FACILITY: MONTICELLO NUCLEAR GENERATING PLANT

LICENSEE: NORTHERN STATES POWER COMPANY (NSP)

SUMMARY OF MEETING TO DISCUSS MONTICELLO 10 CFR §50 APPENDIX J EXEMPTION REQUEST

Figure 2. Core Spray System Containment Penetrations

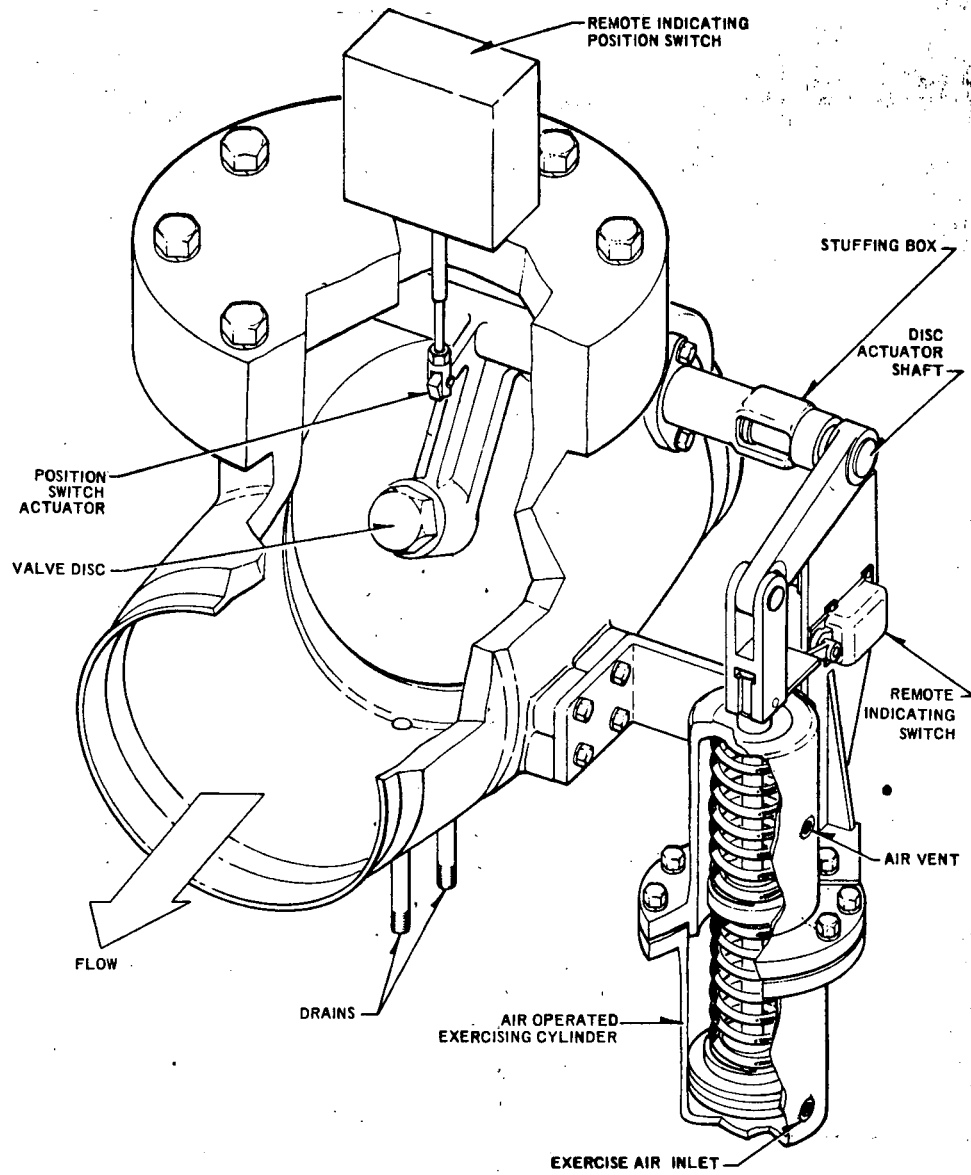
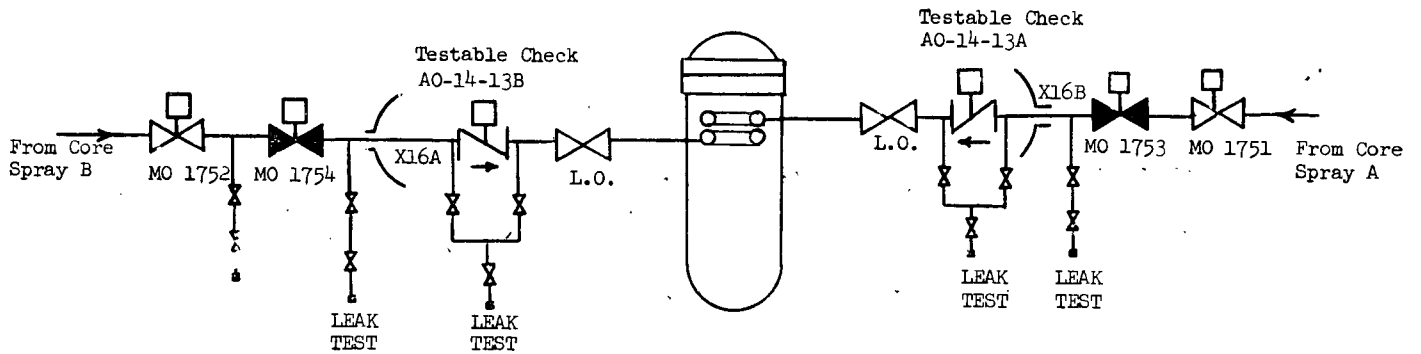
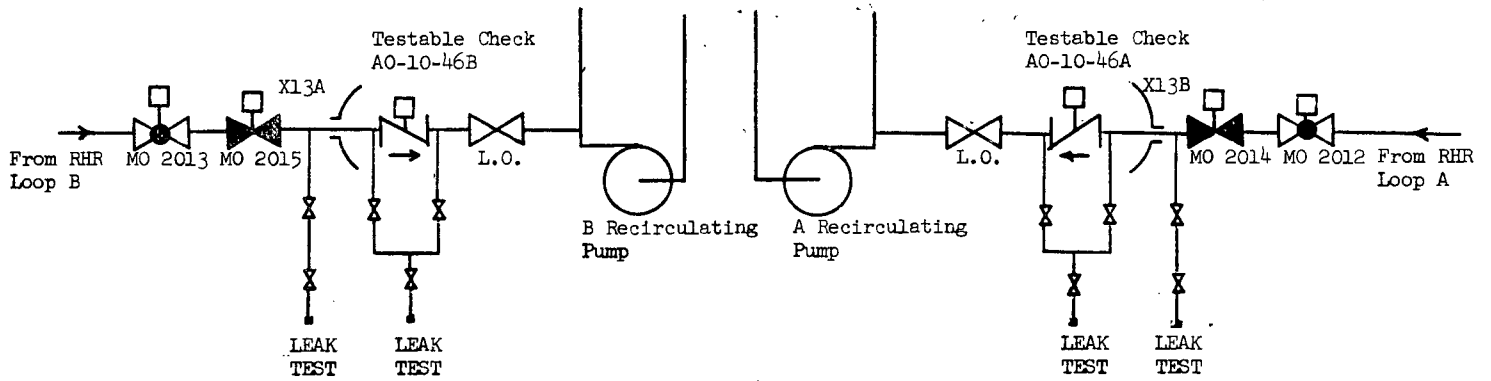
Testable check valves are installed in each core spray and low pressure coolant injection (LPCI) line (Figures 1, 2, and 3). Table 5.2.3 of the Monticello FSAR lists these valves as the inner isolation valve in each line. Each line has two motor operated valves immediately outside the containment vessel which serve as the outside isolation valves. These motor operated valves are either normally open or open following a safeguards actuation signal. They may be closed manually by an operator in the control room.

The testable check valves in each core spray and LPCI line have been included in the Monticello Type C test program. They have consistently failed to meet the Technical Specification limit on maximum air leakage for any penetration or isolation valve of 17.2 scfh at 41 psig. The valves have been disassembled for maintenance on the following occasions to enable them to meet this criterion:

Alternative (c) was proposed by NSP in a letter dated May 5, 1976 from Mr. L. O. Mayer, to Mr. Victor Stello, USNRC, "Request for Exemption from Certain Requirements of 10CFR50, Appendix J." This exemption request proposed a redefinition of which valves in the lines in question should be considered the containment isolation valves.

Alternative (c) is a valid solution for the following reasons:

1. Request to exempt testable check valves in the LPCI and Core Spray Lines from Type C testing - NSP requested that a second motor operated valve outside containment be designated the redundant isolation valve. NSP will consider a Technical Specification change which would establish a maximum allowable liquid leakage from the piping and components outside the outboard isolation valves. The liquid leakage limit would be used to demonstrate that there is a sufficient period of time, prior to system depressurization, to manually close either motor operated valve such that the check valves will not become containment leakage barriers at any time.

Figure 4. Torus Spray Containment Penetrations

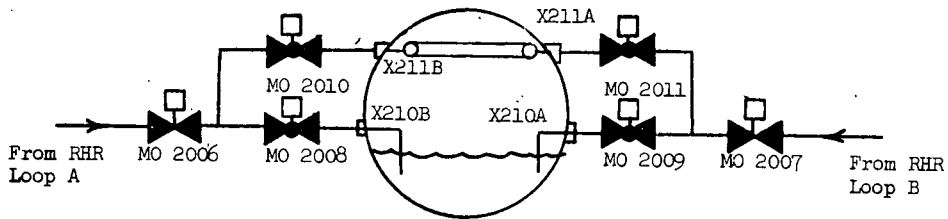
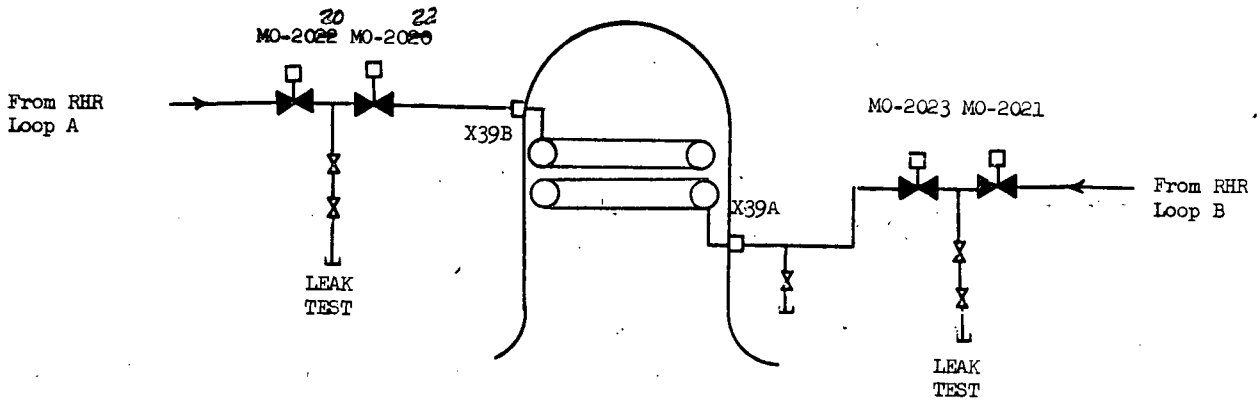
Two motor operated valves are installed in each torus spray and drywell spray line (Figures 4 and 5). These valves are normally closed, but may be opened following an accident to suppress torus or drywell pressure. Exemptions are requested because these penetrations will not constitute a containment leakage path and because of the following testing difficulties:

Torus Spray Line Isolation Valves	No provision for testing
Drywell Spray Line Isolation Valves	Inner isolation valve cannot be tested in the correct direction. This valve is a wedge type gate valve.

Following an accident these lines are pressurized by the RHR pumps to a pressure well above P_a . Each RHR circuit is supplied by two pumps. No potential for containment leakage exists under normal conditions.

If both RHR pumps in a circuit fail to start, some leakage past the motor operated valves in each line can be expected to occur. This leakage will be retained within the RHR piping, however, and presents no problem since the RHR piping is a low leakage barrier which is effectively an extension of the containment boundary.

During the long-term period following an accident, one RHR circuit may require maintenance. The RHR circuit is isolated from the torus and the drywell by the two motor operated valves in each line. At this time, containment pressure is well below P_a and leakage will be minimal. In the event both motor operated valves in a torus or drywell spray line leak excessively, additional maintenance block valves are provided in each RHR circuit to assist in sealing off any containment leakage. All lines will be water filled, a condition which further reduces the magnitude of any leakage.

2. Request to exempt torus and drywell spray motor operated valves from Type C testing - NSP will determine if the RHR system pressure can be maintained following a postulated loss-of-coolant accident, considering potential single active failures and post-accident, maintenance functions. If a system pressure, greater than containment pressure, can be maintained under such circumstances

then the valves in question would not serve as containment leakage barriers.
